# STEREO IMPACT

PROBLEM REPORT

PR-3007

<b>Assembly : SIT Instrument</b>	<b>SubAssembly :</b>
<b>Component/Part Number:</b>	<b>Serial Number: 01</b>
<b>Originator: Walpole</b>	<b>Organization: UMd</b>
<b>Phone : 301-405-6217</b>	<b>Email : Walpole@sampex.umd.edu</b>

COMPANY: <b>STEREO/IMPACT/SEP/UMd</b>	
TITLE: <b>SIT ACOUSTIC DOOR ACTUATOR</b>	
CODE:	DRAWING NO: <b>11010</b>
SIZE:	REV:
SCALE:	SHEET: 1 OF 1

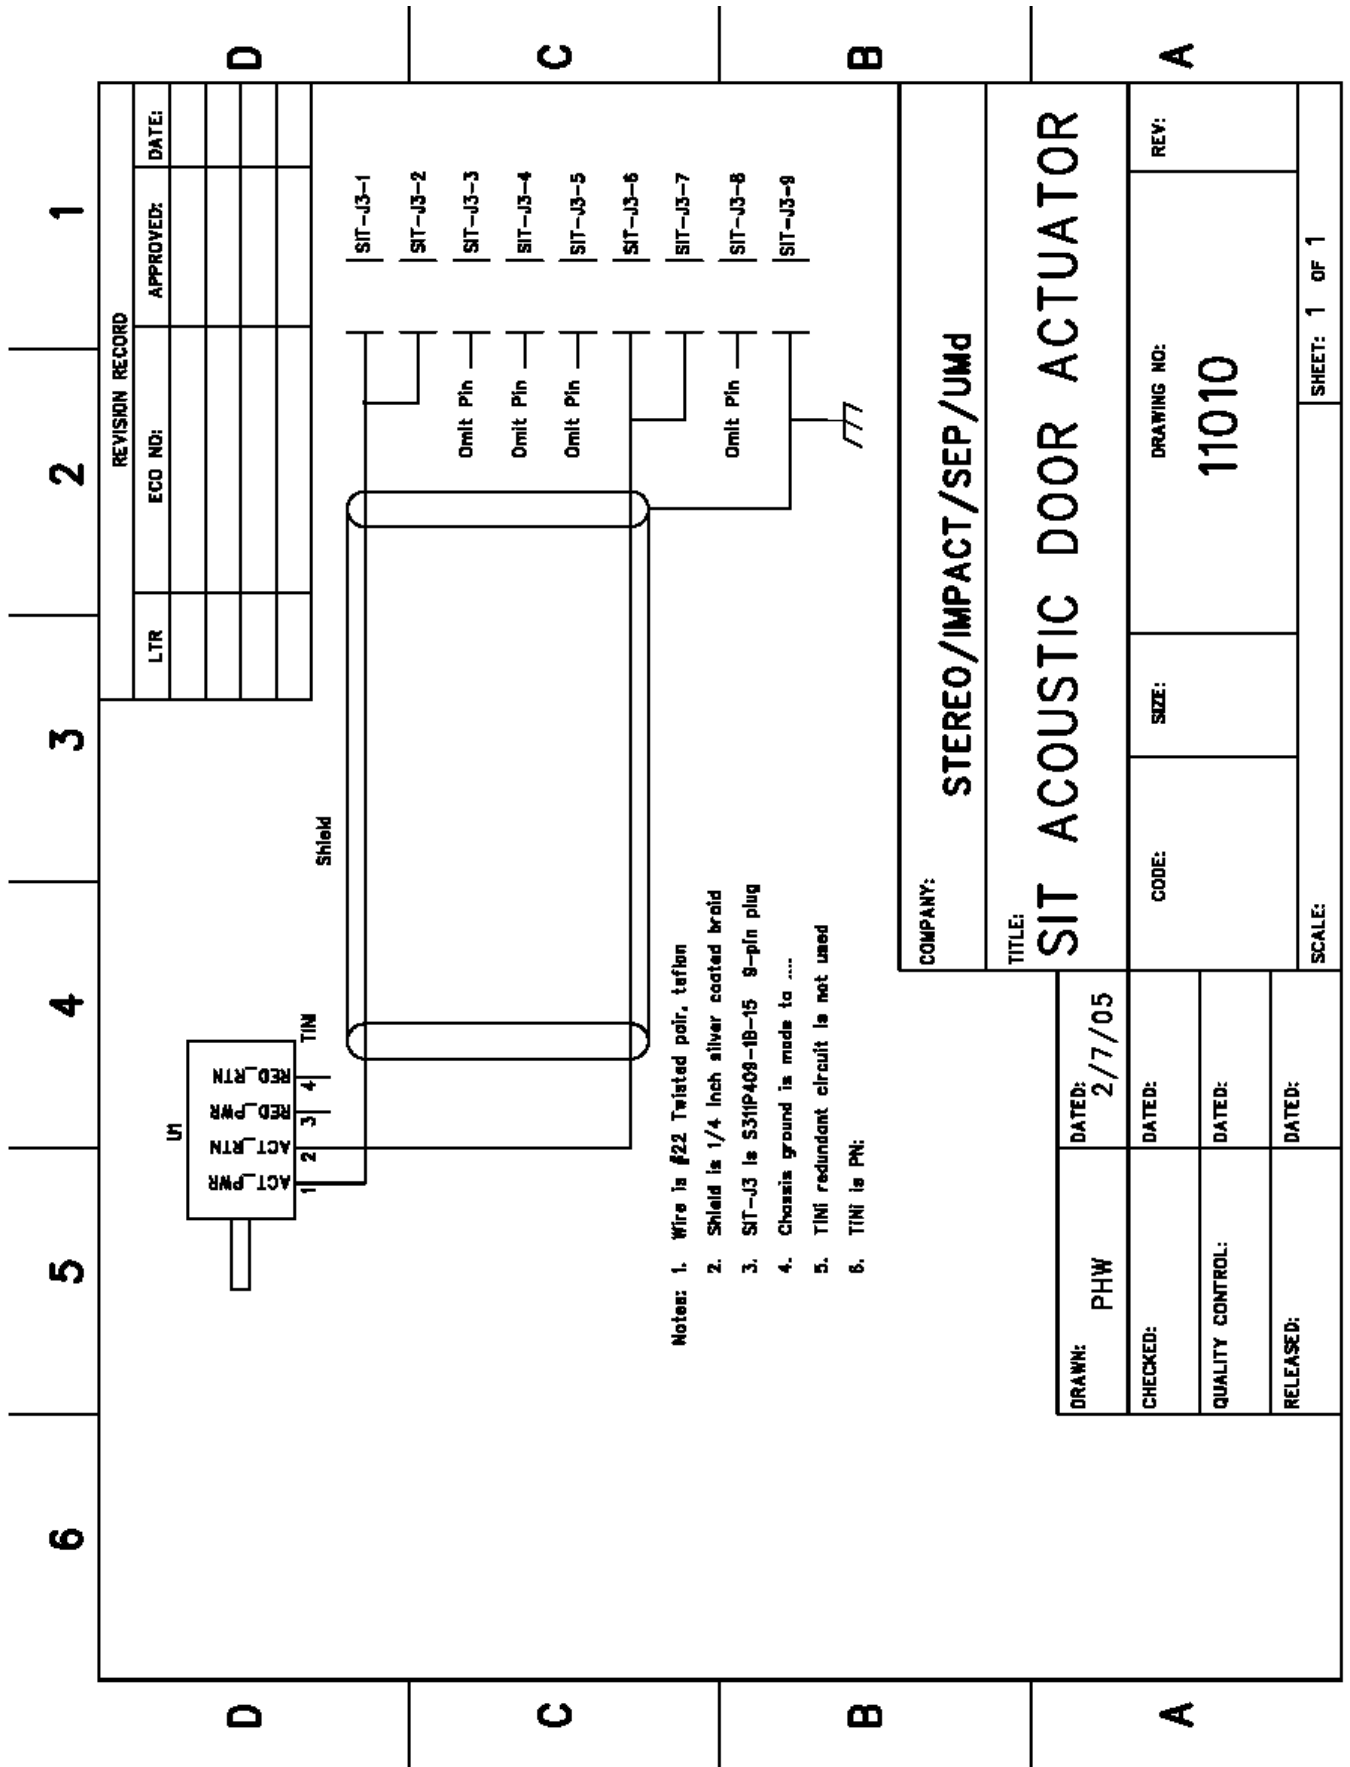
During thermal balance testing, a check of the wiring of the SIT Acoustic Door actuator showed that from the outside of the chamber, the wiring was incorrect. We expected to see about 5 ohms between pins 1 and 6 and between 2 and 7 per table 4.8.3 below taken from the Harness Specification document. We expected pins 1 and 2 to be shorted to each other. Likewise pins 6 and 7.

What we found was 5.5 ohms between pins 1 and 2 and between 6 and 7. Pins 1 and 6 were shorted together, as were pins 2 and 7.

We consulted the technician who wired the SIT actuator onto J3 on the SIT box. She confirmed that the wiring error was on SIT and was the result of misunderstanding the wording on the Table.

To allow the SIT door to be opened during TB, a 9 pin – 9 pin adaptor was made correcting the pinout. SIT FM1 harness has been corrected and verified according to the updated drawing. To prevent the problem from occurring on SIT FM2 we have supplied a clarifying schematic (below).
